New Long Beach Courthouse Final Initial Study

August 6, 2009

**Administrative Office of the Courts
2860 Gateway Oaks, Suite 400
Sacramento, CA 95833**

Figure 5. Winter Solstice Shadows: 9:00 a.m. and 3:00 p.m.

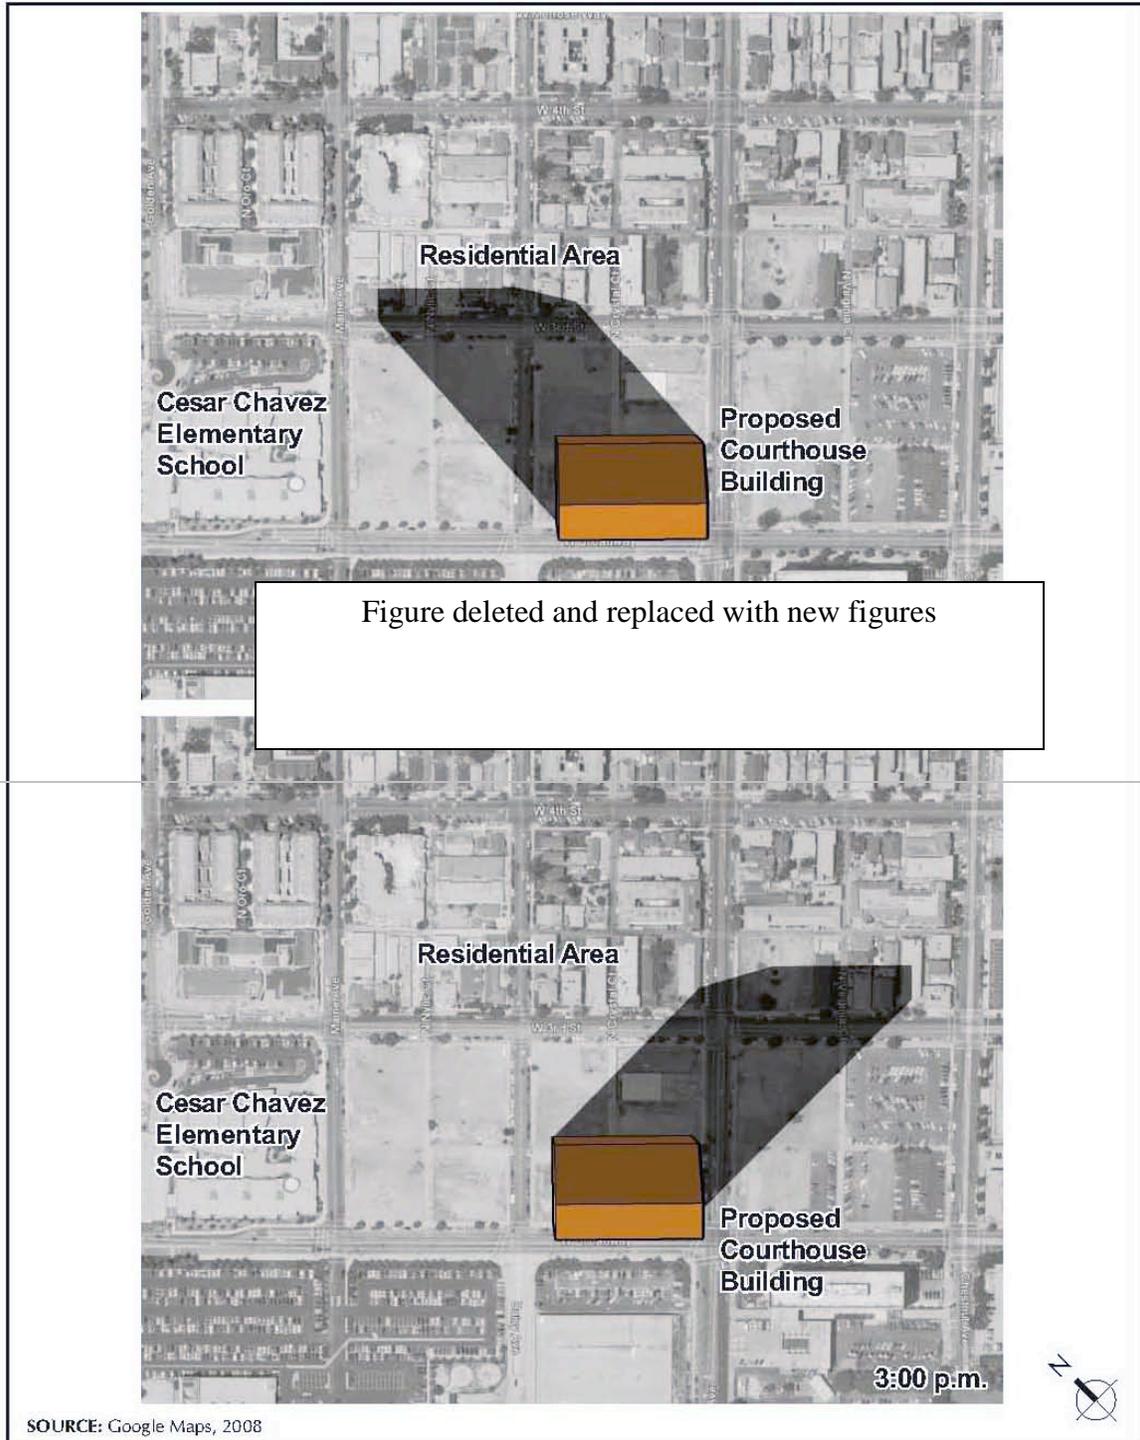
The MND evaluated the shade and shadow effects of the proposed courthouse on sensitive use receptors at the Cesar E. Chavez Elementary School west of the project site. The analysis relies on a conceptual massing model of the proposed courthouse, based on the anticipated square footage and height of the building, and the results of a corresponding shade and shadow simulation using Sketchup. The simulation of the shade and shadow by the proposed courthouse building was performed for the Winter Solstice, Summer Solstice, Autumnal Equinox, and Vernal Equinox. Figure 5 of the MND shows that the proposed courthouse will not shade the Cesar Chavez Elementary School.

The MND's treatment of aesthetics is inadequate under CEQA because the only analysis specific to the Chavez ES is the shade/shadow analysis in Figure 5, and that may be based on a preliminary building model that is an incomplete representation of the building envelope. The MND does not address landscaping along the edge of the site and around the building or building set backs. The AOC should commit to a process of public review and input to the aesthetic and design aspects of the Project.

Analysts ~~prepared a conceptual massing model of the proposed courthouse, based on the anticipated square footage and height of the building to conduct a shade and shadow simulation in Sketchup. The simulation of the shade and shadow by the proposed courthouse building was performed~~ evaluated the project’s shading of nearby areas for the Winter Solstice, Summer Solstice, and Autumnal Equinox, and Vernal Equinox. Figure 5 displays shading impacts to Equinoxes. For the Final Initial Study and Mitigated Negative Declaration, analysts prepared revised shade analyses of the proposed project’s potential tower. Figures 6 through 11 display the potential Winter Solstice shading impacts to the West 3rd Street area including Cesar Chavez Elementary School, Cesar Chavez Park, and the residential area north of West 3rd Street. The analysts’ simulation evaluated the hours between 9⁸ a.m. and 3⁴ p.m.

As shown in Figure 5, Within the ~~proposed courthouse will not shade the Cesar Chavez Elementary School.~~ potential 50-foot tall commercial building zone, a building near the corner of West Broadway/Maine Avenue may shade the school between 8 a.m. and 9 a.m. on the Winter Solstice, but the tower portion of project will not shade the school. The project will not shade Cesar Chavez Park on the Winter Solstice, and the project will not shade the school or park on the equinoxes or Summer Solstice.

~~There is~~ The project will have a shadow effect of two hours to eight hours on the south-facing sides of the residences directly along West 3rd Street between Maine Avenue and Nyllic Court Magnolia Avenue during the ~~period of the Winter Solstice-~~ Winter Solstice. The longest shading will occur in the area between Daisy Court and Crystal Court. The project’s tower will shade the residences along West 3rd for approximately one hour between 9:00 a.m. to 10:00 a.m. (Figure 4.2.2 1, Winter Solstice, between 9:00 a.m. and 3:00 p.m.). After 10:00 a.m., the proposed new courthouse would not cast a shadow over any of the residential developments along West 3rd Street. The proposed building will shade the residential area north of the project site, but shading two hours in the early morning and late evening on the Spring and Fall Equinoxes.
